STATE OF VERMONT AGENCY OF TRANSPORTATION

PROPOSED IMPROVEMENT BRIDGE PROJECT TOWN OF HARTLAND COUNTY OF WINDSOR

RECORD PLANS	
CONTRACTOR:	KUBRICKY CONSTRUCTION CORP. - WILTON, NY
RESIDENT ENGINEER:	DARYL BASSETT
CONSTRUCTION BEGAN:	JUNE 10, 2014
CONSTRUCTION COMPLETE:	NOVEMBER 5, 2014
RECORD PLANS BY:	DARYL BASSETT & KEVIN KING
I HEREBY CERTIFY THAT ALL THE CONSTRUCTION REQUIRED BY THIS SET OF DRAWINGS HAS BEEN ACCOMPLISHED AS INDICATED HEREIN.	
BY	RESIDENT ENGINEER
DATE	2/22/16
NOTE: Any further information concerning final quantities, amounts or other details relative to this project may be found by contacting Vtrans Records Management.

US ROUTE 5 (MAJOR COLLECTOR), BRIDGE NUMBERS 62A AND 66

PROJECT NAME: HARTLAND	PLOT DATE: 3/3/2014
PROJECT NUMBER: BHF BPNT(I2)	DRAWN BY: A.J. GOUDREAU
FILE NAME: zllc260+yp.dgn	CHECKED BY: S.G. FARNSWORTH
PROJECT LEADER: M.A. COLGAN	SHEET 4 OF 55
DESIGNED BY: S.G. FARNSWORTH	
BR 62A TYPICAL ROADWAY SECTIONS

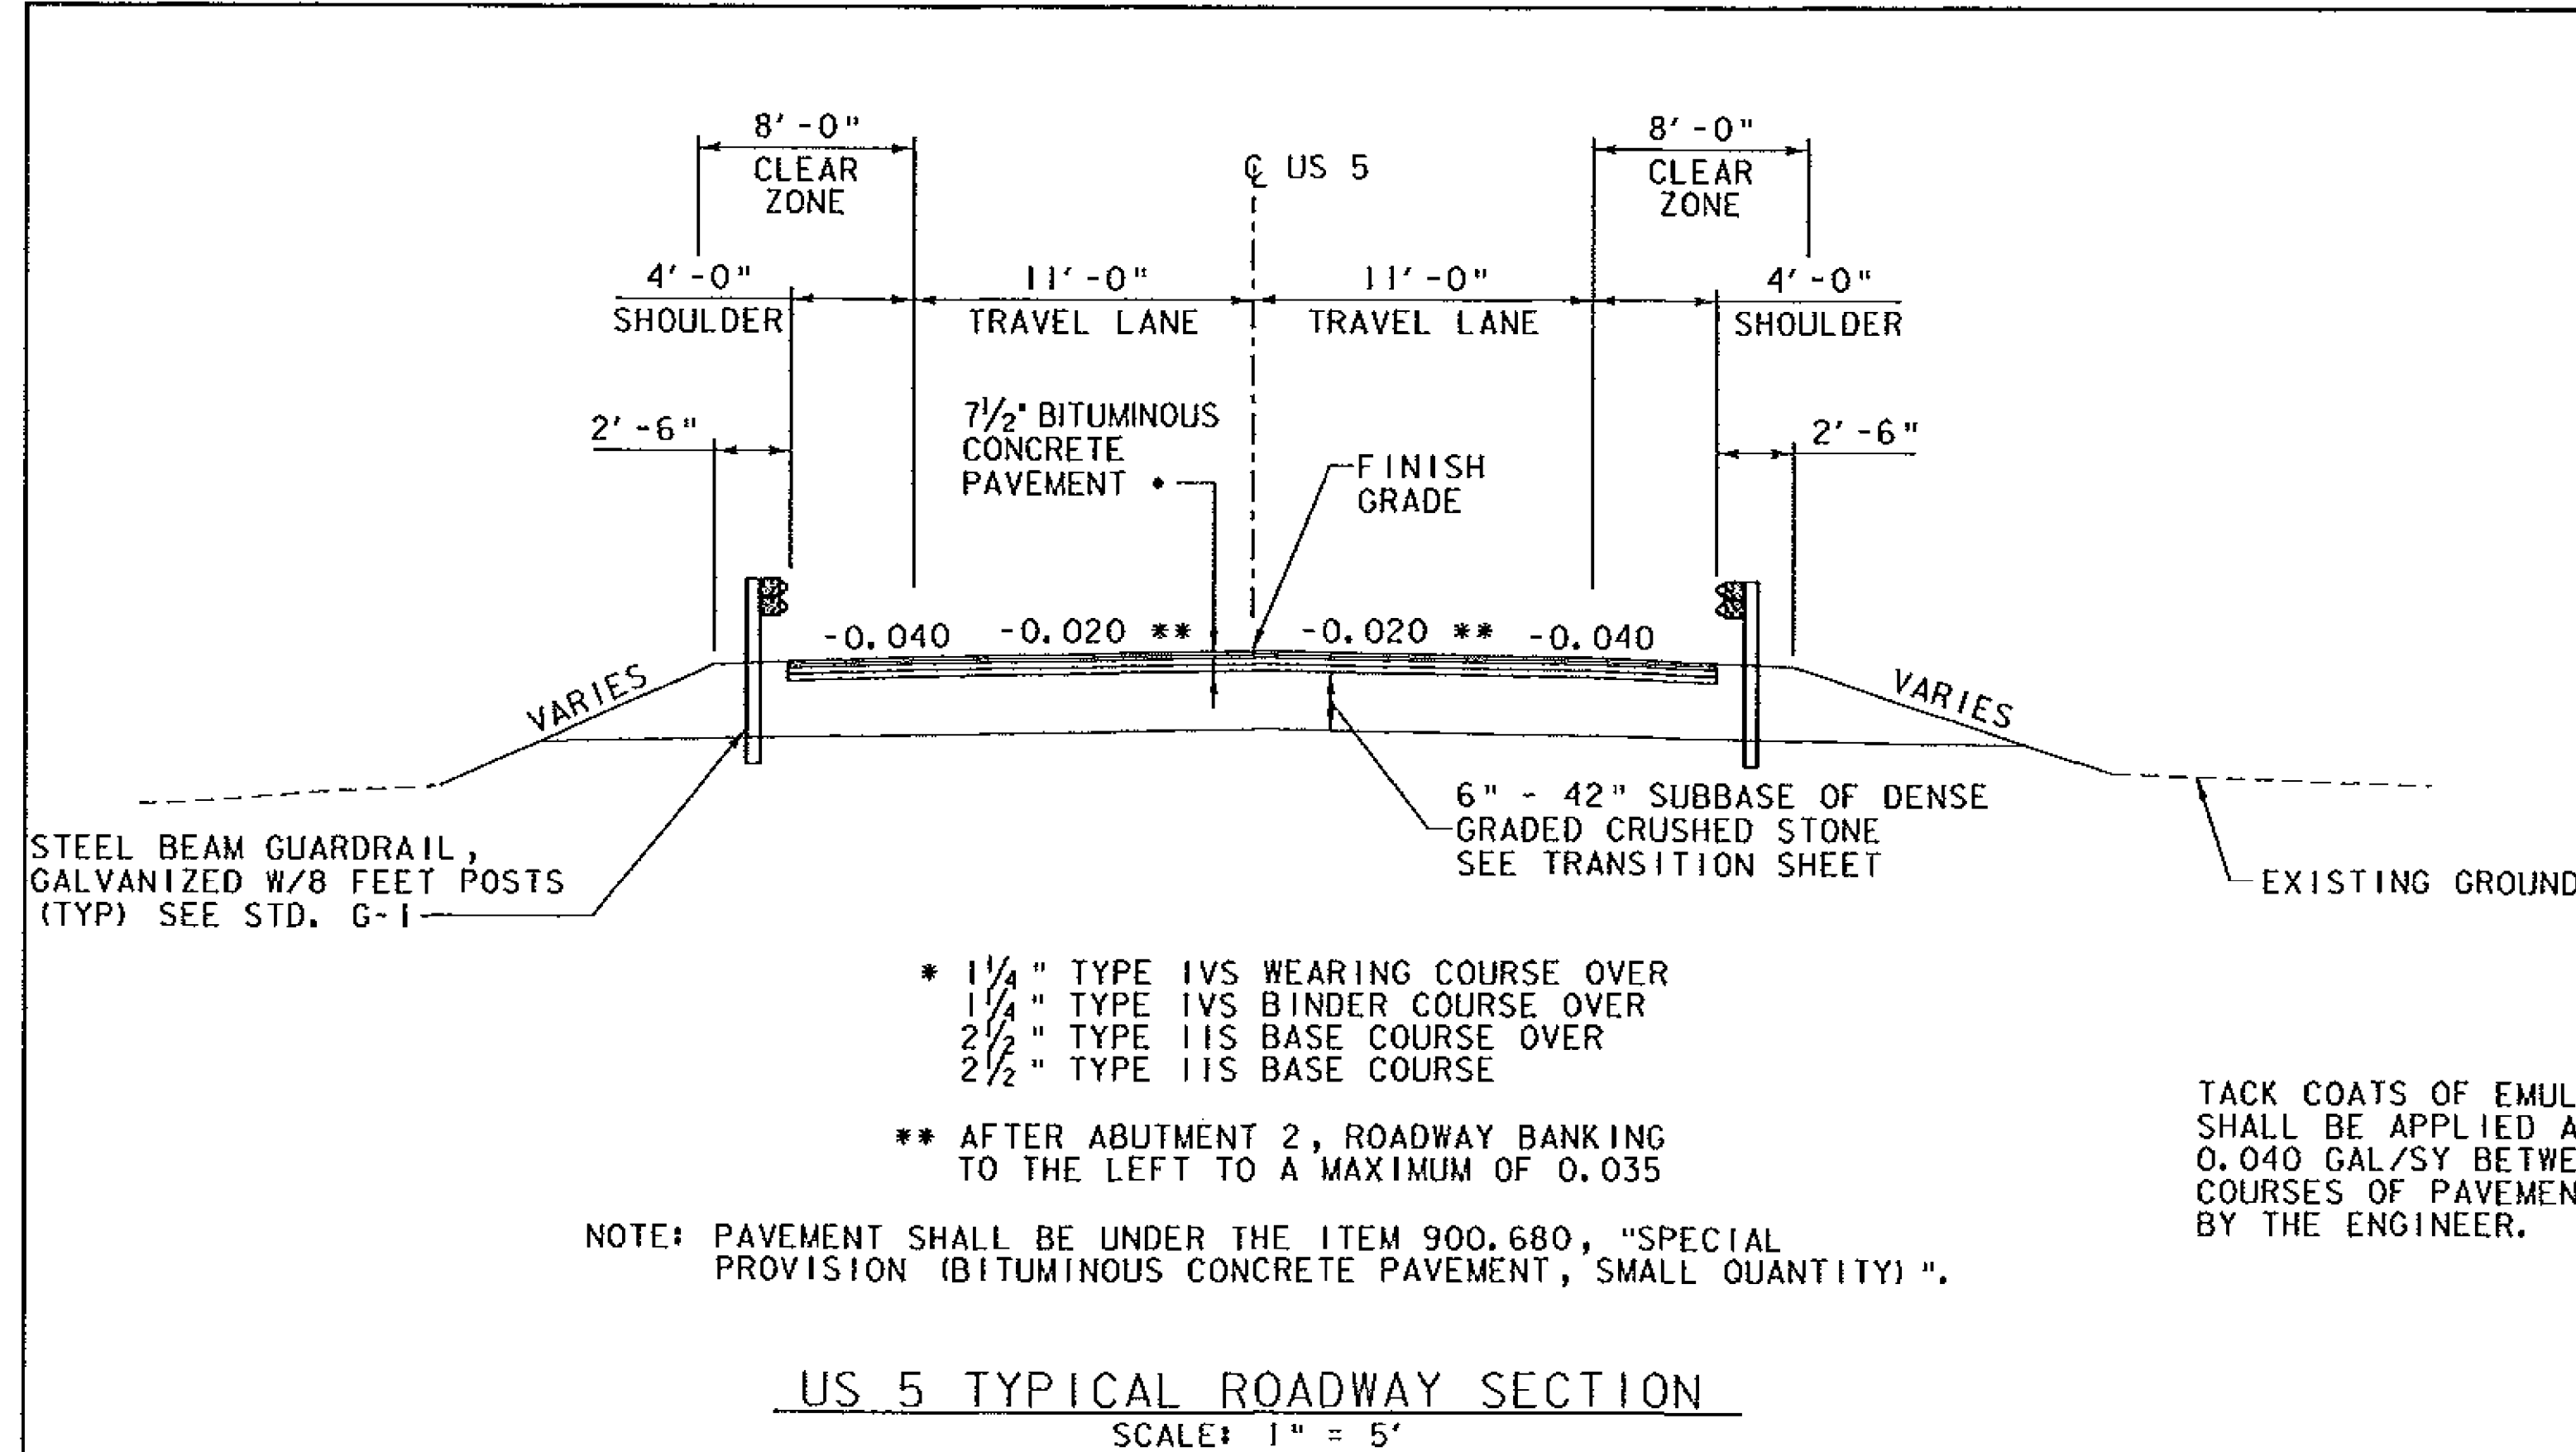
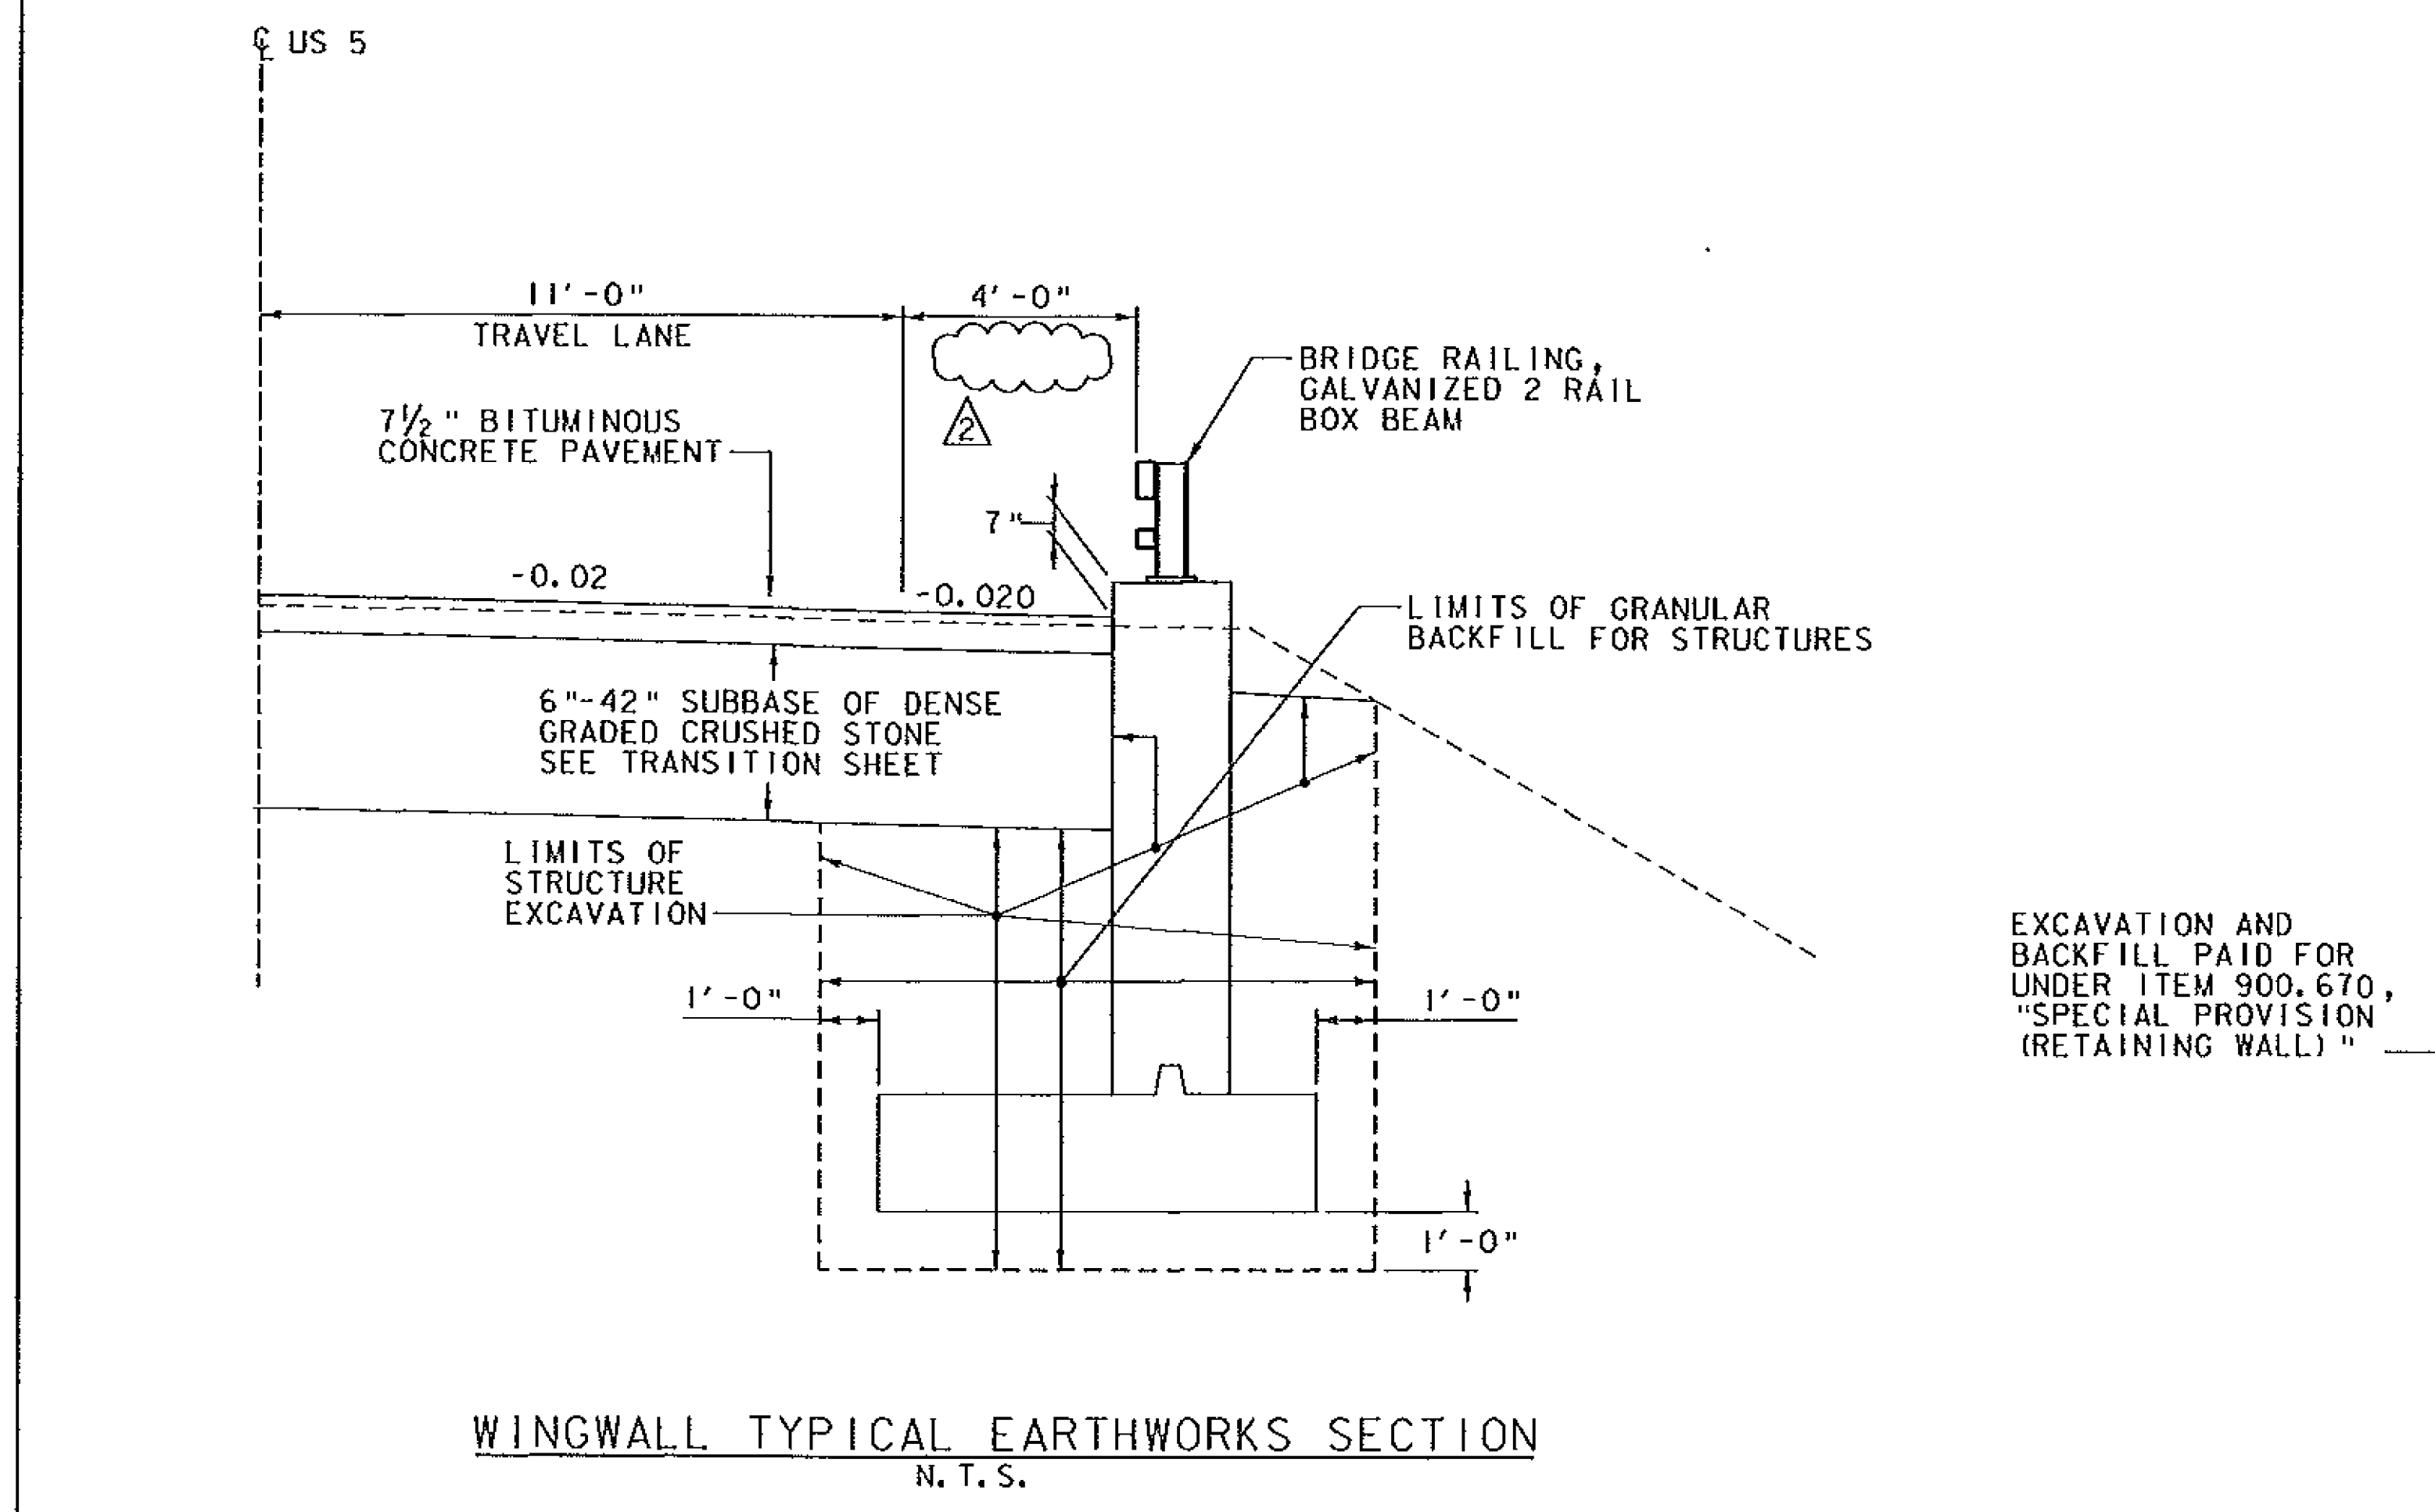
REV.	DESCRIPTION	DATE
△	REMOVED THE WORD "SHOULDER"	3/3/2014
